# Officer Report

| <b>Application Number:</b> | <b>HGY/2026/1946</b>                                                                                             |
| <b>Address:</b>            | 64 Sheldon Avenue, Hornsey, London, N6 4ND                                                                       |
| <b>Proposal:</b>           | Installation of 5 x AC External Condenser Units and 1 x Air Source Heat Pump along rear and side boundary fence. |

*Figure 1. Approved tree retention and landscaping plan approved under HGY/2016/0090 & HGY/2016/0091.*

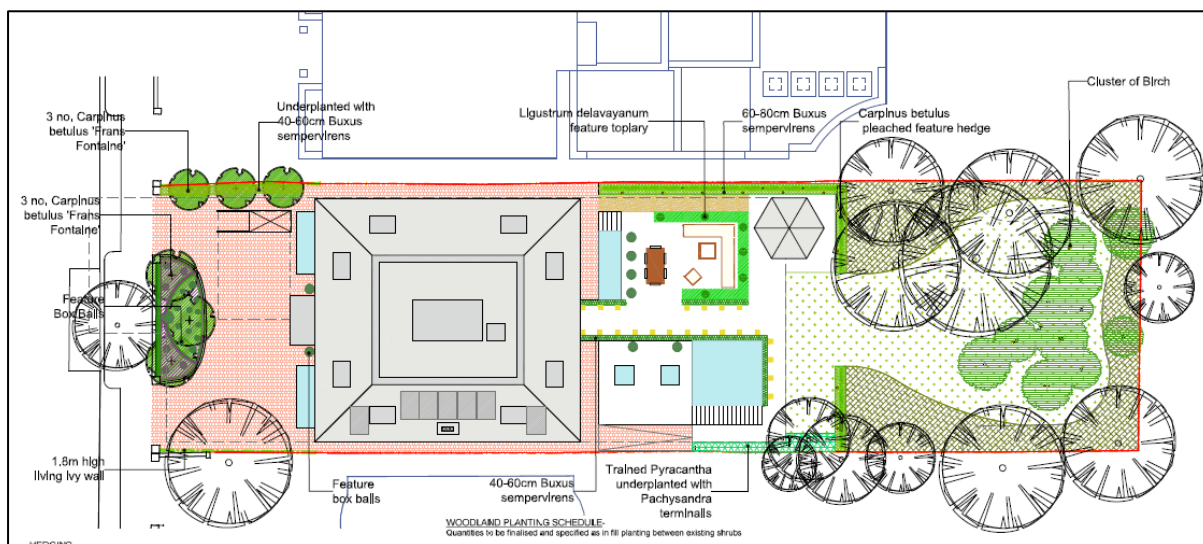
The submitted drawings are not based upon an accurate representation of the approved landscaping scheme. In particular, the plan showing the location of the condensing units does not correspond with the approved planting layout. Furthermore, based upon photos provided in the Highgate CAAC objection, the existing trees as shown on the plans submitted appear inaccurate, with fewer trees observed on the site.

Based on the approved landscaping plans, the proposed plant on the rear boundary appears to fall within the woodland planting area, requiring the introduction of a substantial concrete strip and associated hardstanding.

Such works would be incongruous within this landscaped setting and would significantly erode the extent of approved planting that was intended to soften and mitigate the visual impact of the development. Furthermore, insufficient information has been provided to determine whether the installation of the plant and associated infrastructure would conflict with proposed tree planting or adversely affect existing trees and their root protection areas.

The landscaping strategy was a consideration in the assessment and approval of previous applications on the site, as it was considered essential in mitigating the harmful effects of the development on the character and appearance of the conservation area. The lack of accurate plans showing the relationship between the proposed plant, hardstanding, approved landscaping and existing vegetation means that the full extent of the development and its visual consequences cannot be properly understood.
